WATER PERMIT NO. 8647-3

**SOUTH DAKOTA
WATER PERMIT NO. 8647-3**

FILE DOCUMENTATION**SUBJECT:** Bob Bruns Dam Spillway**DATE:** 2025 August 20

Figure 1: Proposed dam location and unnamed tributary of Firesteel Creek

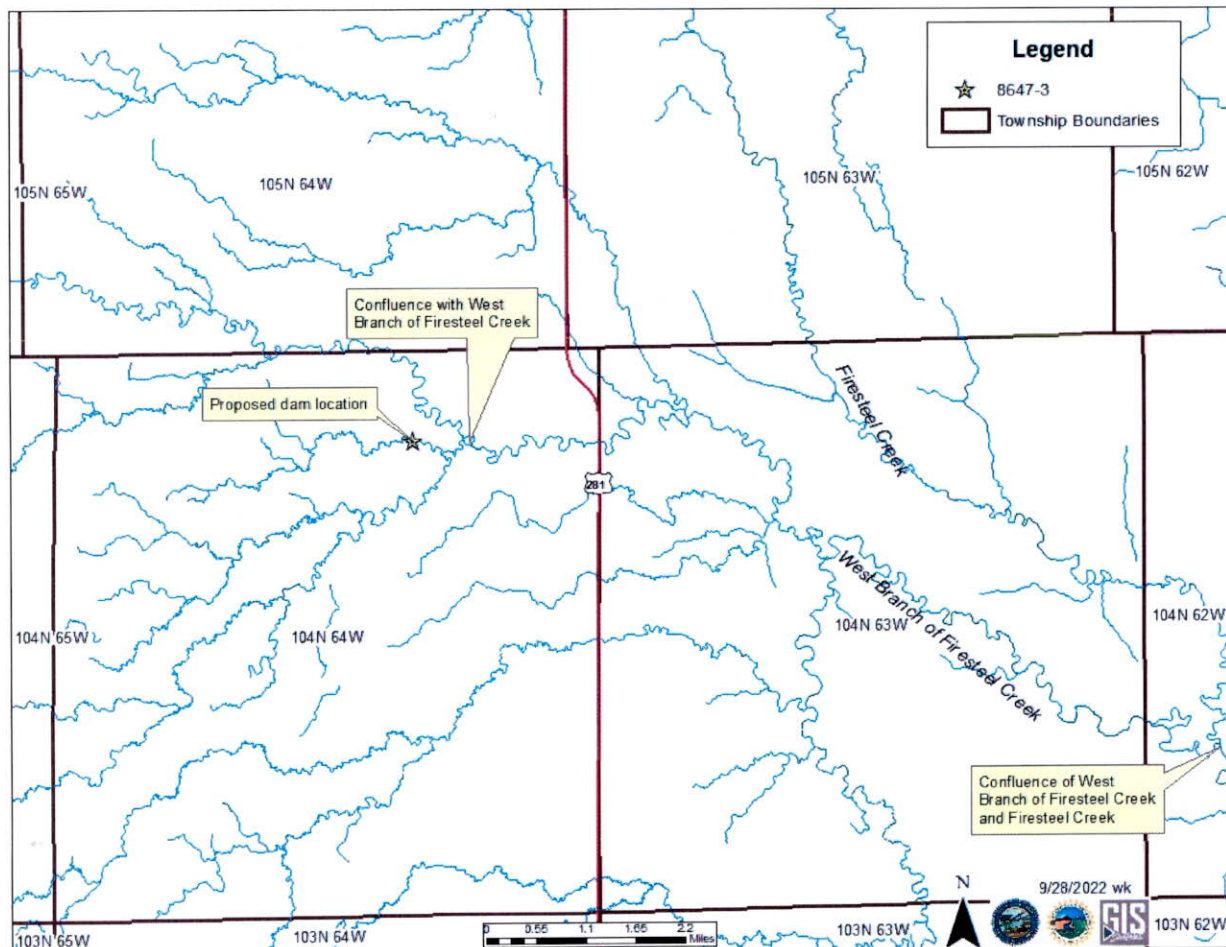
Water Permit Application No. 8647-3 proposes to impound 47.6 acre-feet of water from runoff by constructing a dam on an unnamed tributary of the West Branch of Firesteel Creek. This unnamed tributary is located within the James River basin in northeastern Aurora County. It flows in a generally eastern direction to a confluence with another unnamed tributary before confluenting with the West Branch of Firesteel Creek (shown in Figure 1). Hamilton (1985) describes streams in Aurora County as generally ephemeral, typically flowing only in late winter to early spring due to snow melt and as a result of intense thunderstorms in late spring and summer.

Figure 2: Plot of annual yield for the watershed above the proposed dam against probability of occurrence (note percent in Table 1 have been converted to decimal). Note this plot and trendline is only applicable for this specific watershed location and area.

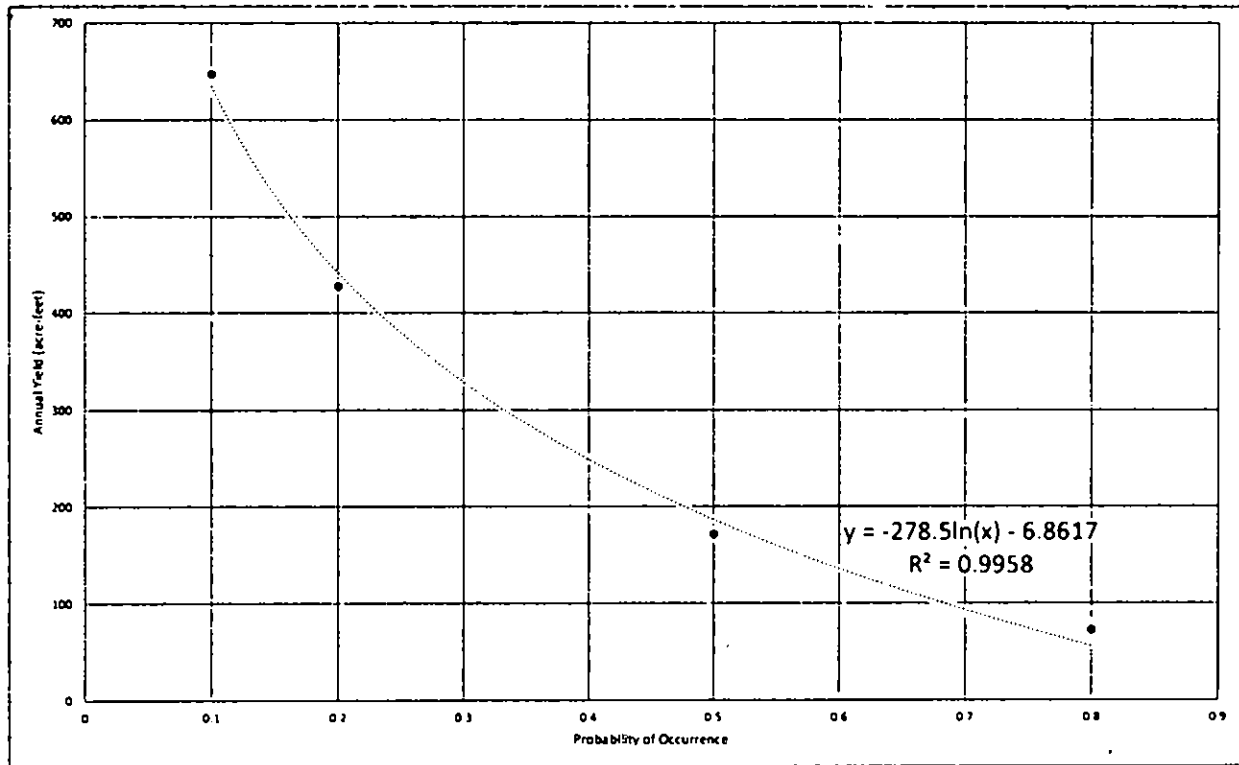
To estimate the percent chance of occurrence of enough annual runoff to provide a full fill of the reservoir to the elevation of the primary spillway (normal storage, 47.6 acre-feet), the total runoff from Table 1 was plotted against probability of occurrence (showing in Figure 2) (chance of occurrence was converted to probability of occurrence). The plotted data shows a very good correlation (the closer a r square value is to 1 the better the fit or correlation of the trendline to the data points) to a logarithmic trendline (shown on Figure 2). Solving the trendline for a volume of 47.6 acre-feet results in an estimated percent chance of annual occurrence of 82% to go from dry to full normal storage.

Figure 3: 2020 FSA imagery of the area downstream of the proposed dam

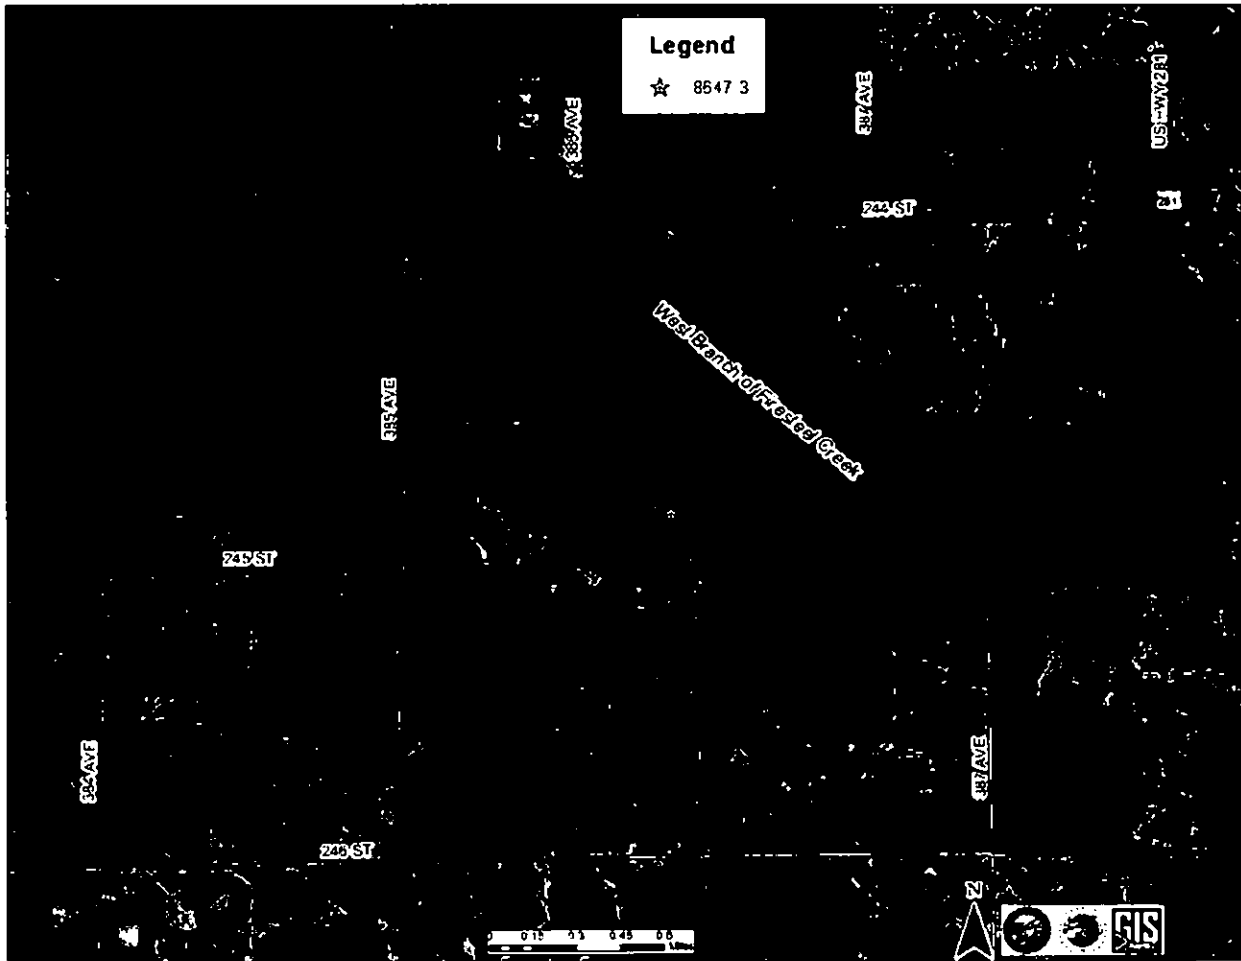
There are no water rights/permit or location notices on file between the proposed dam location and the West Branch of Firesteel Creek (Water Rights, 2022a and 2022b). There are also no water rights/permits the between the confluence of the unnamed tributary that this proposed dam is located on and the West Branch of Firesteel Creek and the confluence of the West Branch of Firesteel Creek with Firesteel Creek (Water Rights, 2022a). These confluences are shown in Figure 1 and a closer map of the proposed dam location is shown in Figure 3.

Given the lack of water rights/permit between the proposed dam location and the confluence of the West Branch of Firesteel Creek with Firesteel Creek, the application, if approved, is not expected to unlawfully impair existing appropriative users. Approximately 0.5 stream miles downstream of the proposed dam location, this unnamed tributary confluences with another unnamed tributary of the West Branch of Firesteel Creek. This relatively short distance between the proposed dam location and the confluence with another tributary, in addition to there being an 80% probability of annual watershed yield exceeding the requested dam storage, indicates that this application, if approved, would not be expected to unlawfully impair downstream domestic users. Out of an abundance of caution, a low flow bypass requirement for downstream domestic use is recommended as a qualification. The submitted preliminary design for the proposed dam includes a low-level water control structure that could be used to bypass low flows as needed.
